Accessibility Survey

City of Downey Consuelo Street - Paramount Boulevard To Bonita Street

Date of Inspection
3/15/2017

Disability Access Consultants

Change In Level West Of Paramount Boulevard @ 33.918772007638, - 118.156709074974

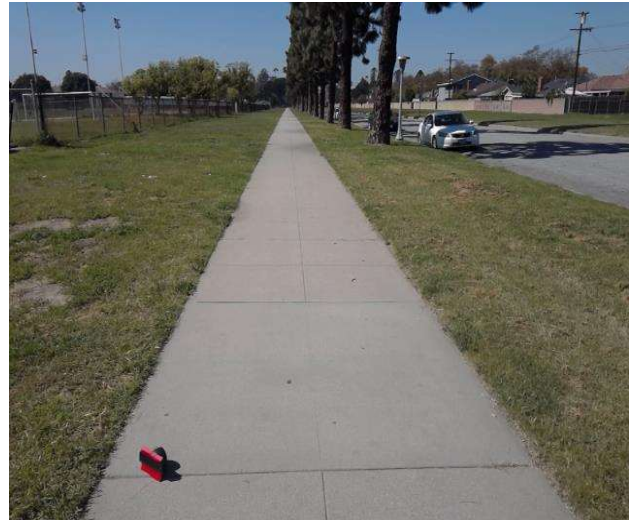
There is a change in elevation greater than recommended value.

On-Site Finding 0.37 inches

Ensure that the change in elevation is within the recommended value.

Recommendation Up to 0.25 inches

Change In Level West Of Paramount Boulevard @ 33.918858812865, - 118.156892806292

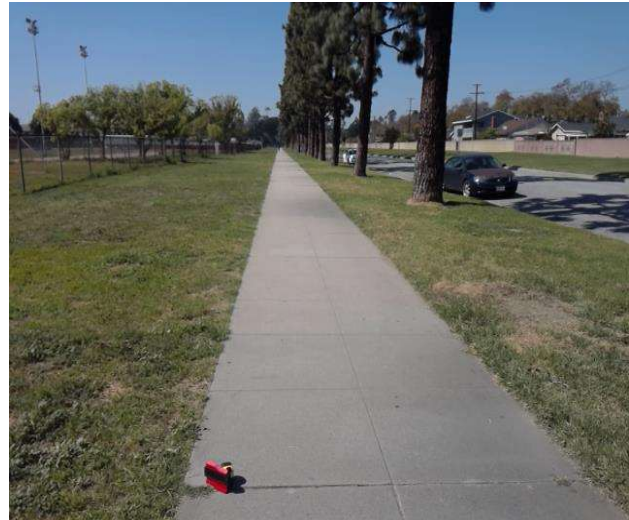
There is a change in elevation greater than recommended value.

On-Site Finding 0.50 inches

Ensure that the change in elevation is within the recommended value.

Recommendation Up to 0.25 inches

Change In Level West Of Paramount Boulevard @ 33.919980595531, - 118.159115016460

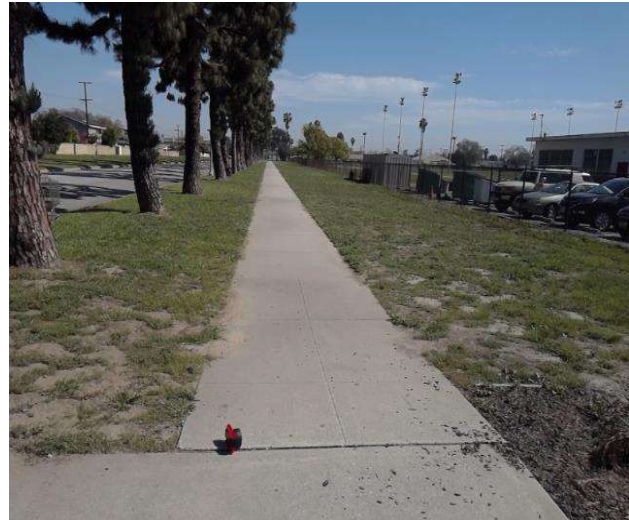
There is a change in elevation greater than recommended value.

On-Site Finding 0.75 inches

Ensure that the change in elevation is within the recommended value.

Recommendation Up to 0.25 inches

Sidewalk West Of Paramount Boulevard @ 33.920021771797, -118.159195482731

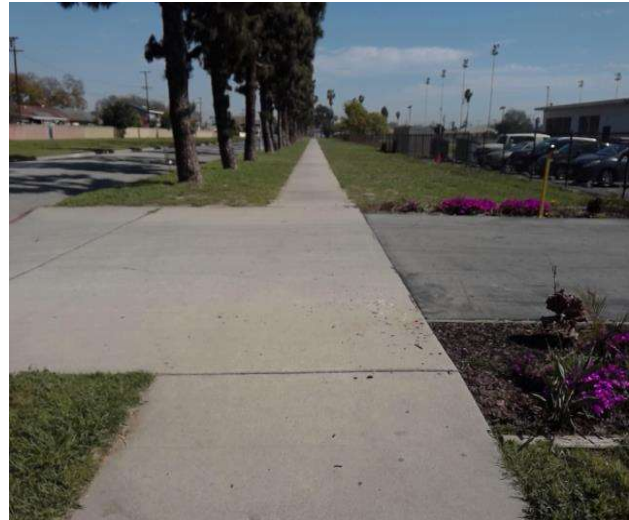
Sidewalk running slope is not compliant.

On-Site Finding 5.60 percent for 2.50 feet

Repave the sidewalk surface with the recommended running slope.

Recommendation Up to 5.00 percent

South Side @ 33.918609525823, -118.156371116638

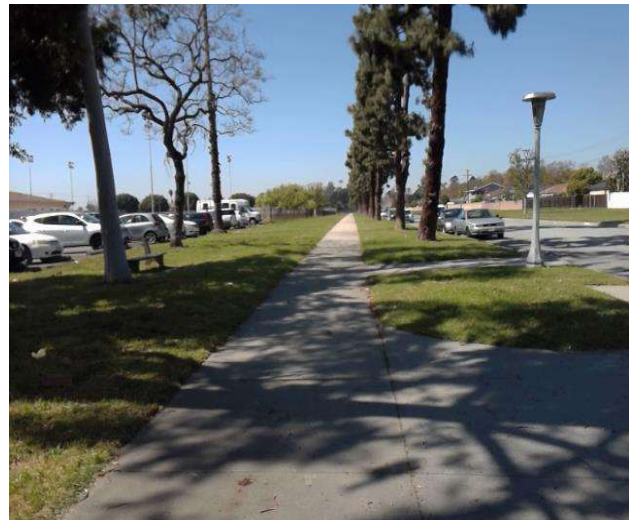
Turn area is not level.

On-Site Finding Not Level

Make sure that the turn area is level.
